Scott Cashen, M.S.
Senior Biologist

Response to Merced County Residents for Responsible Development and California Unions for Reliable Energy Letter, January 15, 2016

Figure 1a. Location of trees at Site 3. Red arrows point to trees within the proposed spoils pile relocation areas.

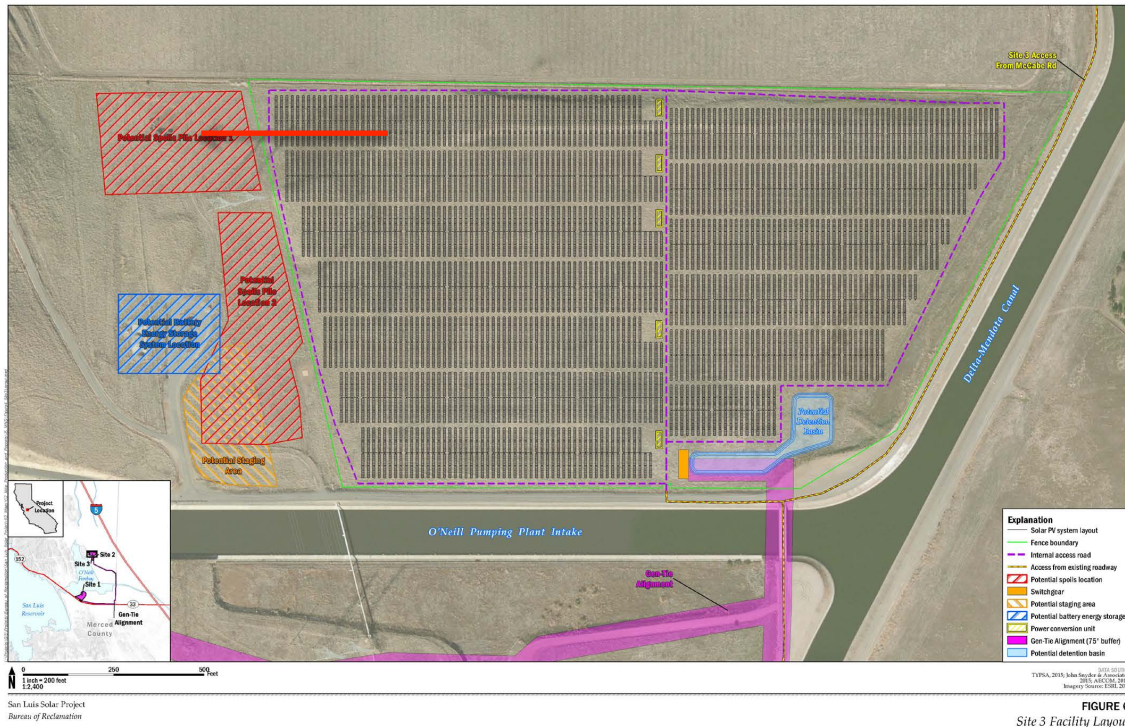
The Swainson's Hawk is listed as Threatened under the California Endangered Species Act. The DEA lists the Swainson's hawk as one of the raptor species that uses non-native grassland, trees, and shrubs in the O'Neill Forebay area.¹⁹ It subsequently indicates there is "no nesting potential on sites" and that occurrence of Swainson's hawks would be limited to "transient flyover and foraging potential only."²⁰ This information is incorrect. Swainson's hawks use trees, bushes, or utility poles for nesting.²¹ These features exist within the Project sites and proposed gen-tie corridor (Figures 1 and 2).

Figure 3. Swainson's hawk nest detected approximately ½ mile west of Site 3 during surveys for the Quinto Solar Project.

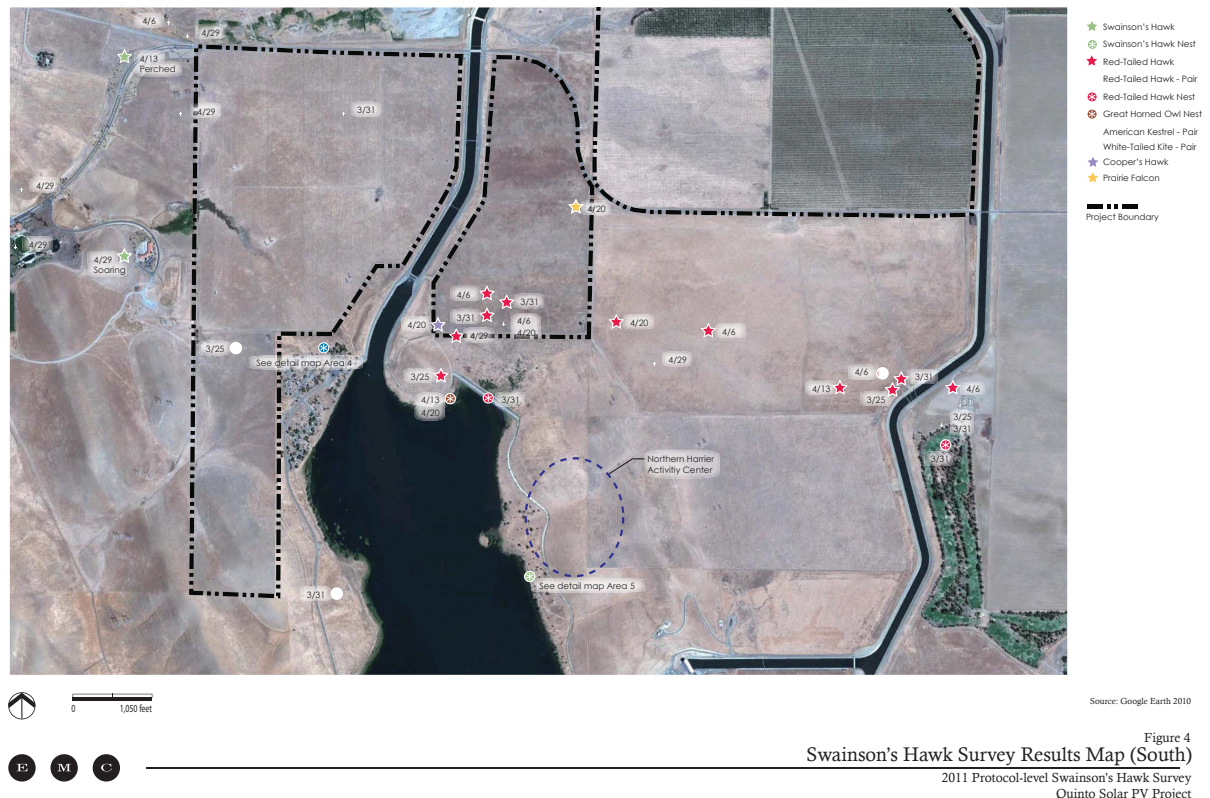
1. Biologists for the Quinto Solar PV Project detected Swainson's hawk nest sites 0.61 miles south and 0.70 miles north of the Quinto Solar PV Project site.²⁴ One of those nest sites is located approximately ½ mile west of Site 3 (Figure 3).
2. There are multiple CNDDB records of Swainson's hawk nest sites south (0.6 to 1.8 miles) of Site 2.²⁵ In addition, Swainson's hawks have nested in the interior live oak tree that is immediately adjacent to (approximately 150 feet south of) the proposed staging area for Site 1.²⁶
3. The San Luis Transmission Project DEIS/DEIR reported: "recent nest records near O'Neill Forebay and observed there during [2014] Project surveys. Potential to nest in multiple locations throughout Project area."²⁷

Site 1 is located immediately adjacent to an emergent wetland that appears to provide suitable aquatic habitat for the California red-legged frog, California tiger salamander, and western pond turtle (Figure 4). In addition, Site 2 is located near a pond and emergent wetland that could provide suitable aquatic habitat for the California red-legged frog, California tiger salamander, and western pond turtle (Figure 5). Consequently, these species could occur in the upland habitats at Sites 1 and 2. Site 3 does not appear to be located within the dispersal distance of aquatic habitat that could support the California red-legged frog, California tiger salamander, and western pond turtle. However, the drainage ditches adjacent to the site could provide suitable breeding habitat for the western spadefoot, and thus Site 3 could provide suitable habitat for aestivation (a state of torpor that occurs below ground).

Coalition-22 The comment states the Project sites provide suitable terrestrial habitat for California red-legged frog, California tiger salamander, western spadefoot, and western pond turtle. See DFW-7 regarding California tiger salamander. The discussion also applies to California red-legged frog and Western spadefoot toad. The western pond turtle is not a Federally-listed species, and therefore is not discussed in EA-14-059.

Figure 6. San Joaquin kit fox habitat model created by Cypher et al. (2013). Magenta = high suitability habitat; blue = moderate suitability habitat.

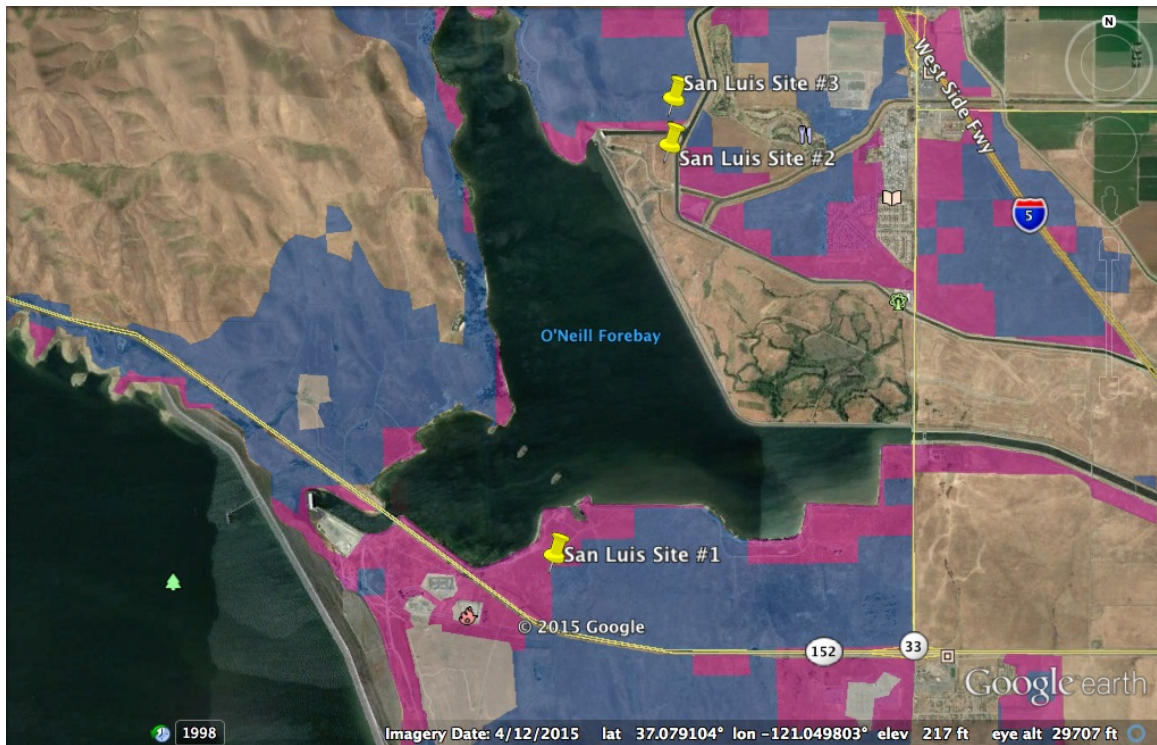
The Project sites contain the attributes associated with medium or high habitat suitability (e.g., grasslands with flat terrain and sparse vegetation). This is consistent with the GIS-based habitat model created by Cypher et al. (2013).⁶⁸ Based on that model, both Sites 1 and 3 contain moderate to high suitability habitat for the San Joaquin kit fox (Figure 6).

Coalition-12 The comment states that the Draft EA and Draft FONSI “conclude, based on the incomplete information ... that the Project will not have any significant adverse effects on kit fox.” As stated in EA-14-059, a search of the California Natural Diversity Database (CNDDB) program for the Project area was used to determine what species may be present. The CNDDB is the primary program used by the U. S. Fish and Wildlife Service (USFWS) and California Department of Fish and Wildlife (DFW) to record where species have been logged by field surveyors. The most current CNDDB version was used at the time of report preparation, and while there were 23 sightings listed within a 10-mile buffer including and surrounding the site, only the 1975 listing was recorded for the Project site, as mentioned in EA-14-059. Also, there are several barriers, including freeways and

Figure 7. “Cores” and “patches” of breeding habitat for San Joaquin kit fox based on habitat connectivity model generated by Penrod et al. (2013).

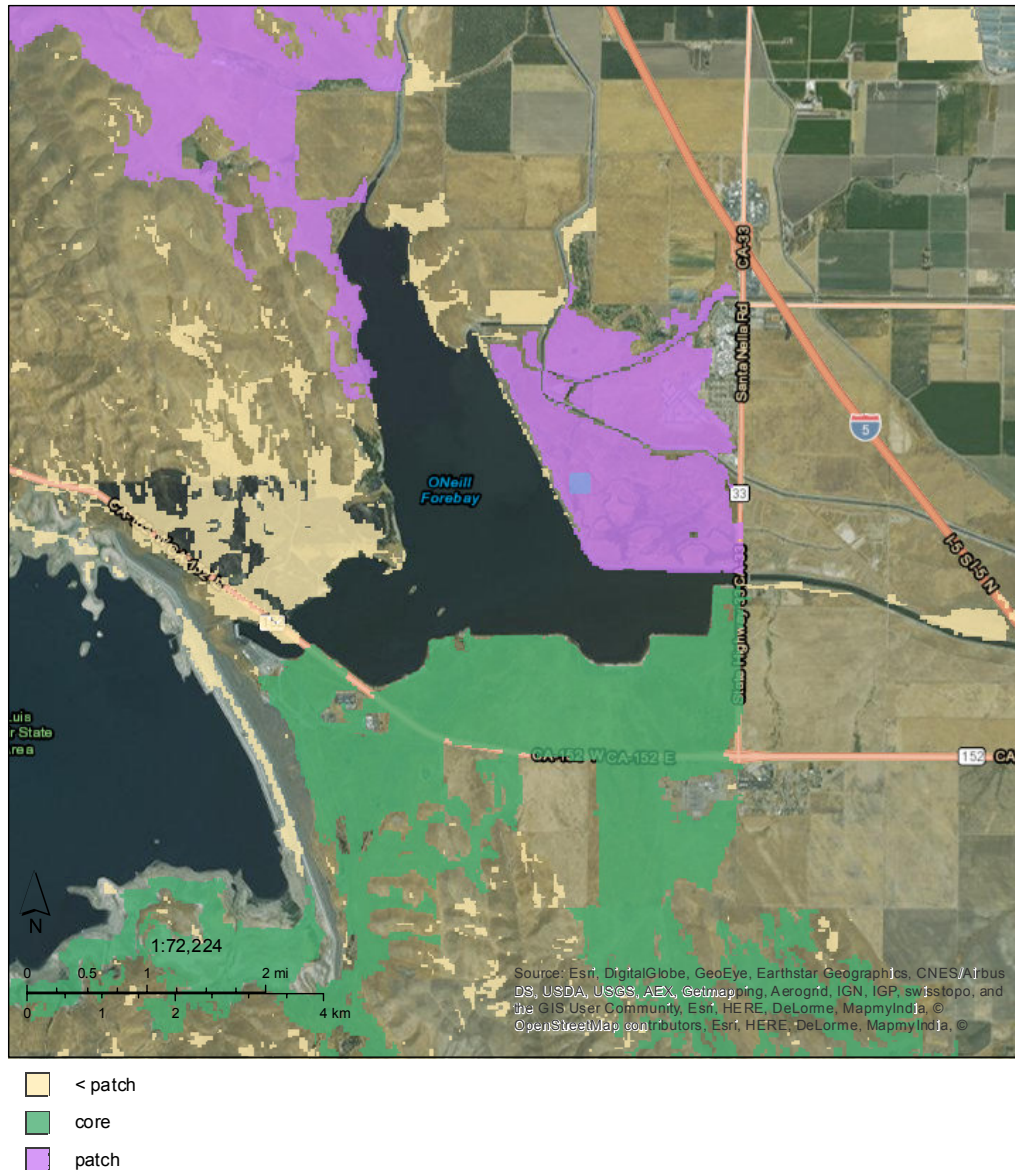
Several scientists have demonstrated the potential for San Joaquin kit foxes to move through and reside in the Project area.⁶⁹ For example, to evaluate critical linkages for dispersal, Penrod et al. (2013) mapped potential “cores” and “patches” of breeding habitat for San Joaquin kit fox.⁷⁰ The Project area provides both cores (Site 1) and patches (Sites 2 and 3) of suitable breeding habitat, and it provides a critical linkage of protected lands for kit fox movement (Figure 7).⁷¹
